UNITED STATES PATENT AND TRADEMARK OFFICE

Office Action Summary

10/023,474

LIANG, LUKE K.

attachment #1

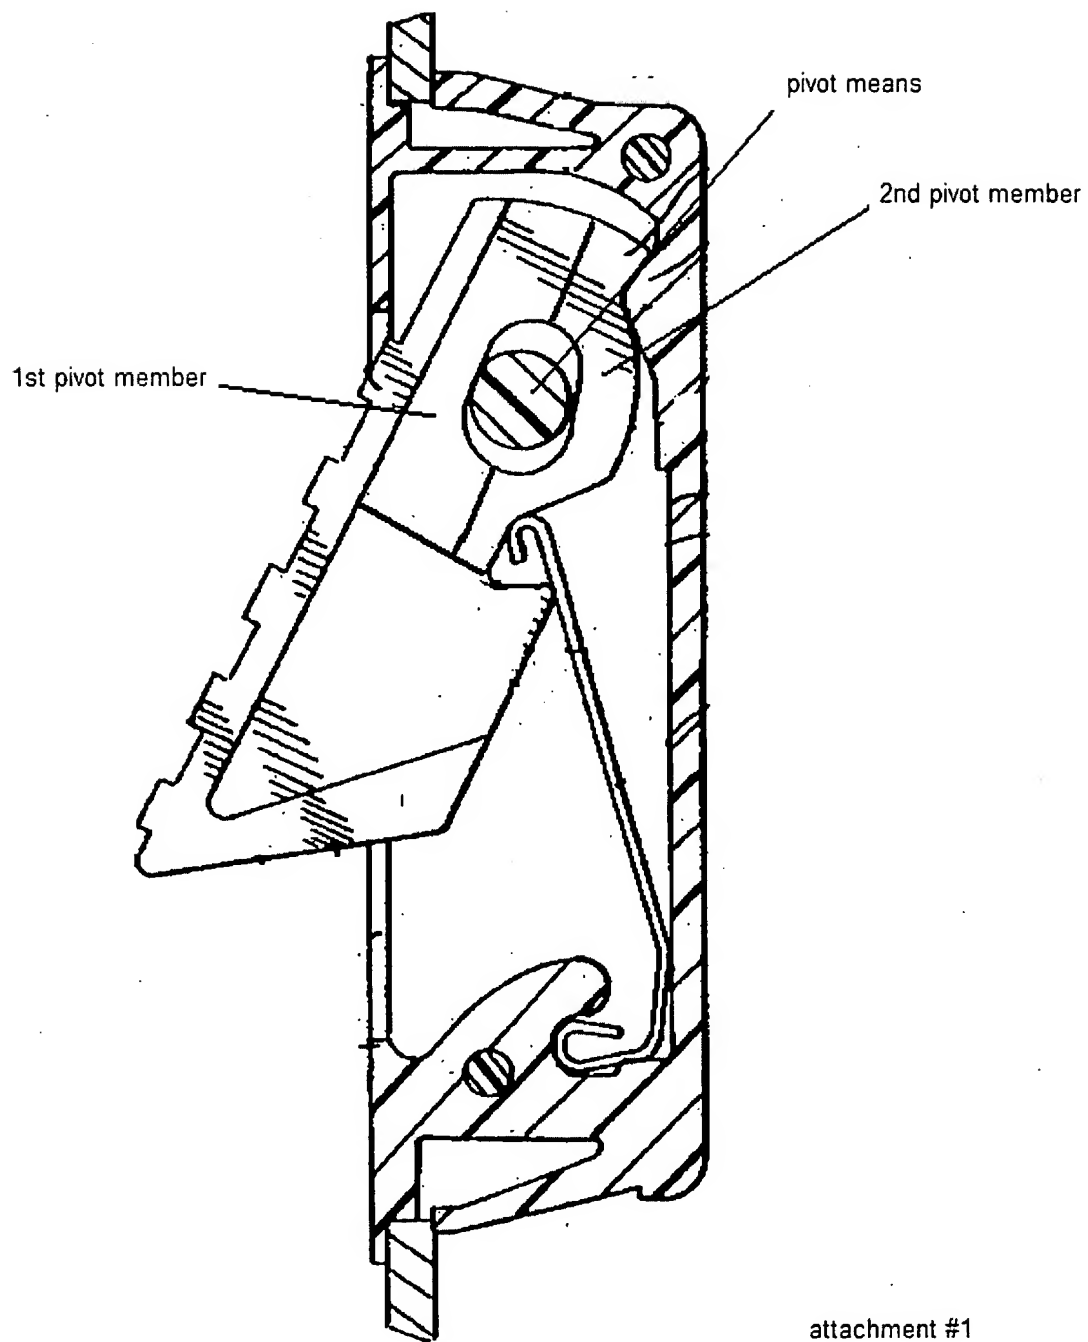
The tumbler further comprises a first pivot member that is capable of being in contact with the pivot means (38) when the tumbler is in the extended position (Figure 6, the opening contact the surface of 38), and a second pivot member that contact the bottom surface of the housing to prevent over travel of the tumbler (see attachment #1).
